WP4-RFD/SPS– NCR and repair action for FPC 1 & FPC 2

18th of June 2024

FPC cavity 1

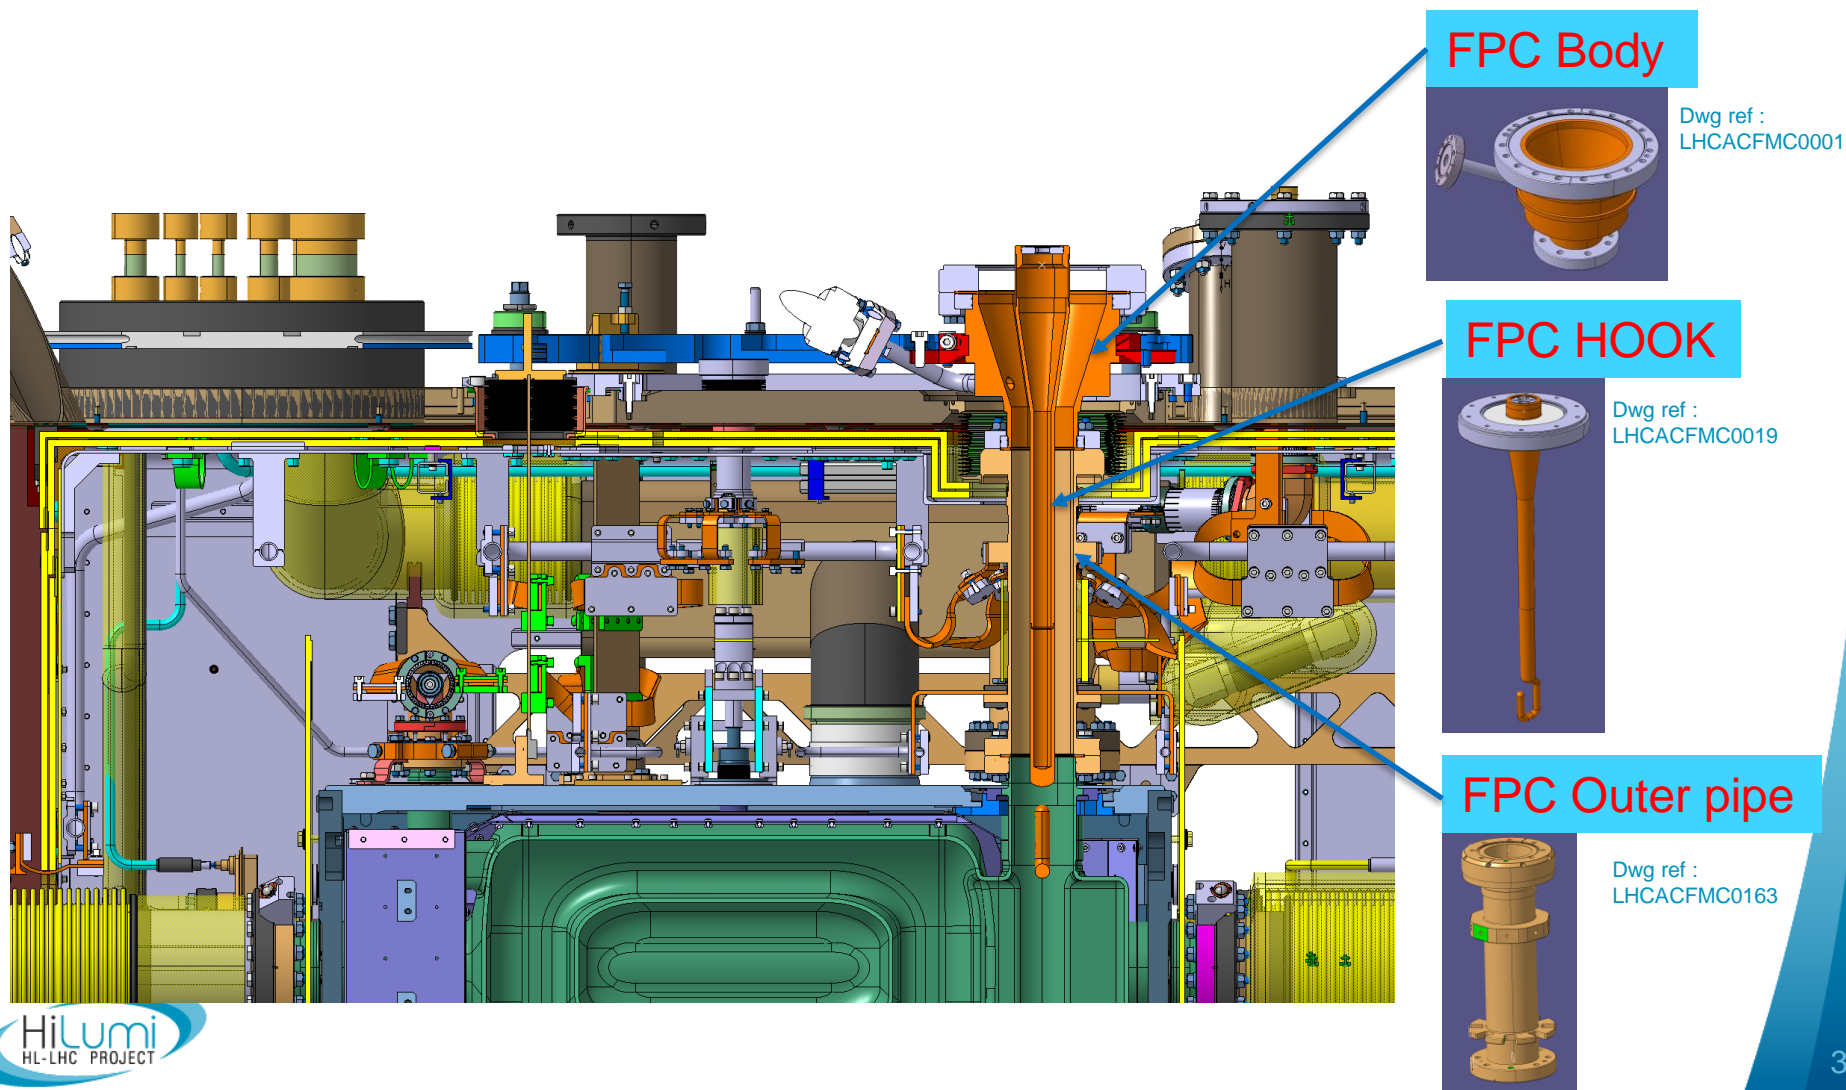
- Non-conformity identified during SM18 tests : [NCR: EDMS 2995980](#)
 - Tilt of the FPC on Cav 1 – short circuit

FPC cavity 2

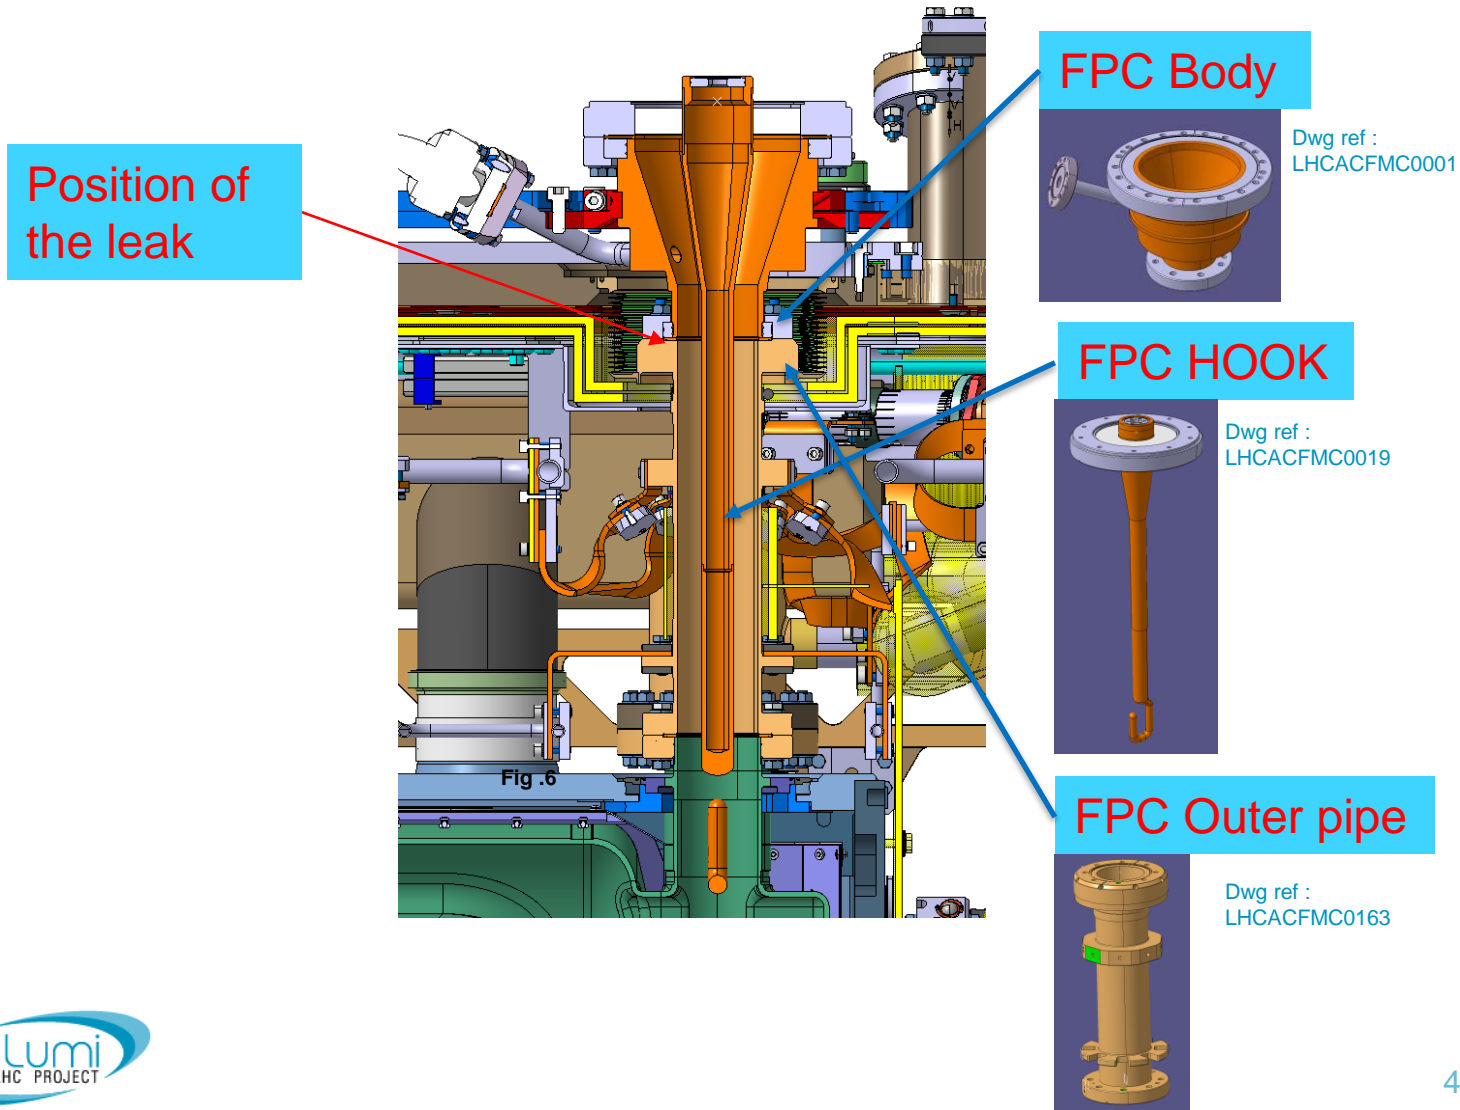
- Non-conformity identified during SM18 tests : [NCR: EDMS 2995891](#)
 - Tilt & Vacuum leak on the FPC of Cav 2

First observations

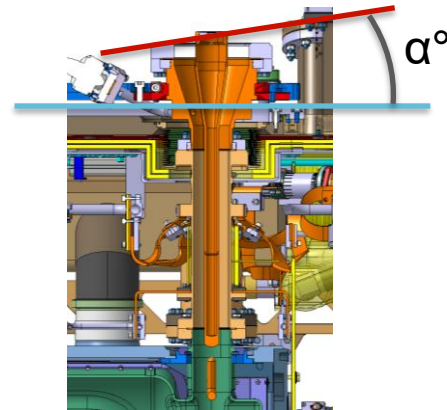
- Preliminary RF checks performed by E.Montesinos and his team showed a problem on FPC of cavity #1
 - A measure of electrical continuity between inner and outer conductor of the FPC showed a contact between the conductors
 - Visually, the top flange FPC look tilted
- WRT the surrounding elements

- A similar but smaller deformation is also visible on FPC cavity #2 but without electrical short and no undesired behaviour noticed during RF checks. This bending is very likely to have caused the vacuum leak.

Mechanical evaluation

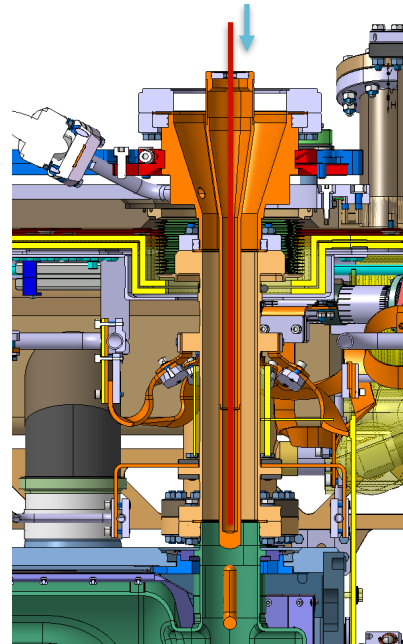
- Both FPCs Cavity #1 and #2 are equipped with optical fibers (see talk of M.Guinchard)
 - The optical fiber sensor installed on both FPCs show no significant strain, excluding a permanent deformation of the FPC outer pipe
 - A $\text{Ø}15.5\text{mm}$ rod has been fitted inside the cooling channel of the hook to exclude a large bending of the hook
- (a large deformation of the hook would have prevented us from fitting this rod)*

Result of radiographic measure (see full results in EDMS 2995980)- courtesy A.Porret

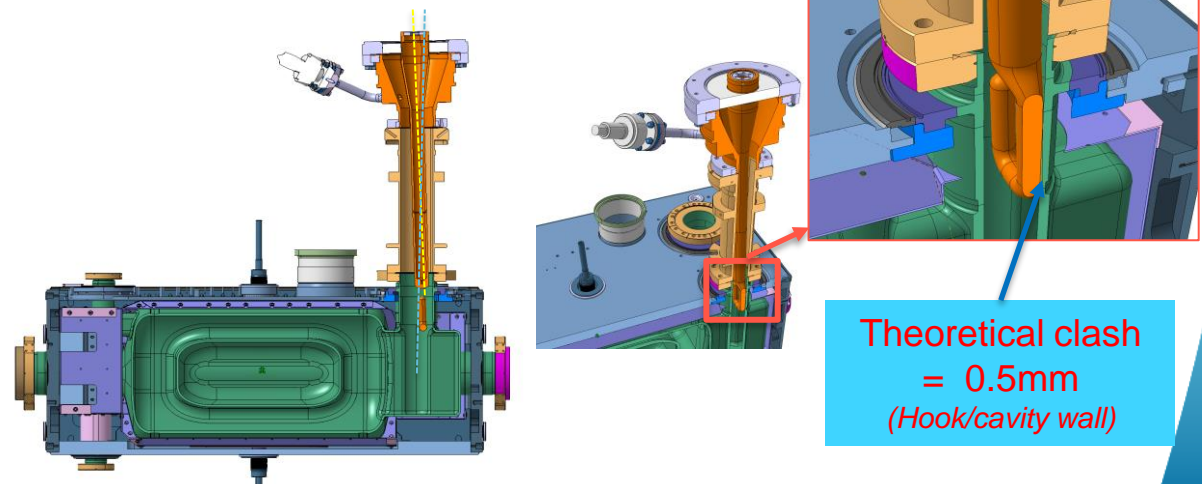
- X-ray confirms our preliminary observations :
 - The hook isn't bended
 - The deviation starts from the top

Root cause analysis - STFC

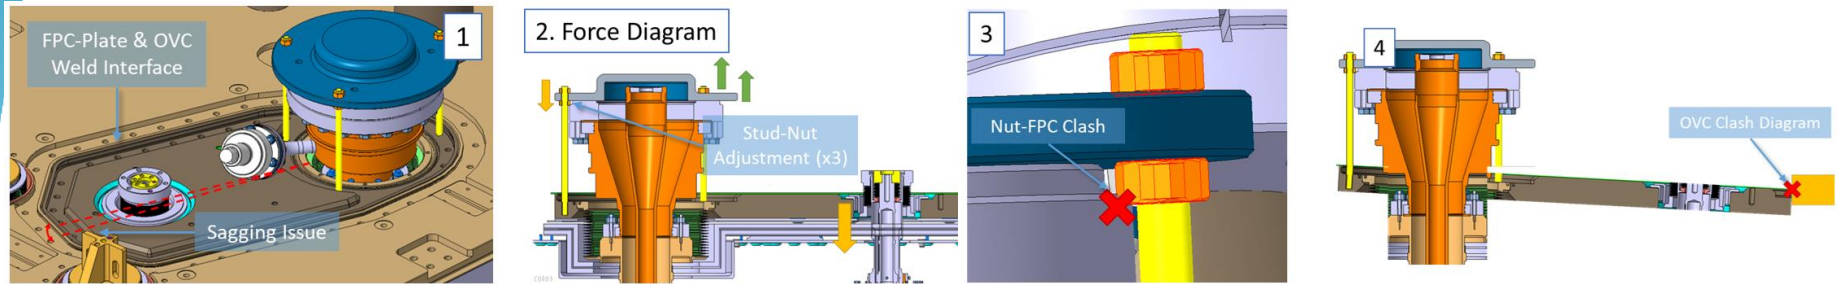
- Preliminary review from STFC suggest that this deformation happened during step 5.8

The root cause was determined to be same for both FPCs; a multi-problem case during step5.8:

- *The FPC-Plate to OVC interface could not be welded due to cantilever sagging.*
- *Correcting the plate pitch was challenging with the FPC-Plate tooling.*
- *A clash between tooling nuts and the FPC caused nuts to round when adjusting and loss of torque feel.*

However, these 3 problems alone can not cause damage since a bellows decouples the FPC and FPC-Plate.

- *As the weld interface correction was attempted, it's suspected an unknown clash between the FPC-Plate and OVC created the force path through the FPC.*

Comment on STFC analysis

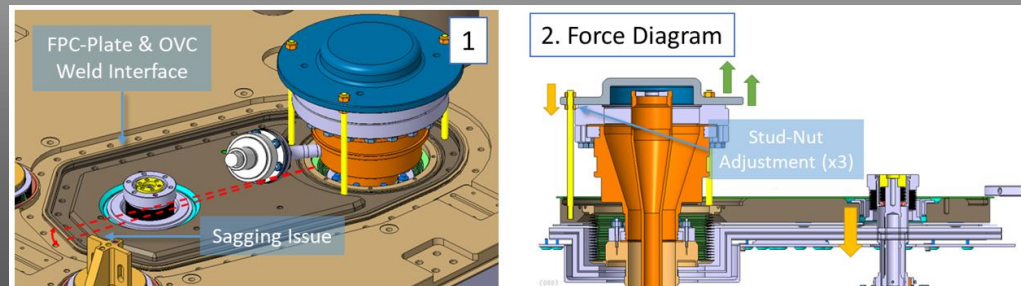
- The force needed on the M8 rods to bend the FPC body would have been ~28KN
(force applied ~75mm away for FPC axis)
- The load to tighten the M8 nuts added to the axial load would have exceeded the maximum allowed stress of the M8 rods.

5-6-5 Lower Gantry using Top Kinematics to align

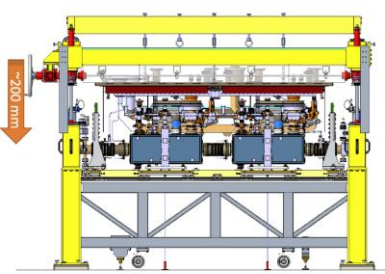
- A misalignment of the top plate WRT cavity string was measured before the top plate has been lowered but noticed only after the top plate has been lowered in position

- The misalignment on Y axis (-7.95mm min) is larger than the FPC aperture margining ($\pm 2.5\text{mm}$)
- There is a possibility that the top plate misalignment lead to a collision on the FPC plate

- Because of the tight environment it is really hard to properly look at the FPC plate passing through the aperture of the top plate. Nevertheless it is of crucial importance that this happens without collision.
- A specific tooling to better adjust the position of the FPC plates need to be designed
- Use the optical fiber installed on the FPC outer pipe to better monitor potential issue.
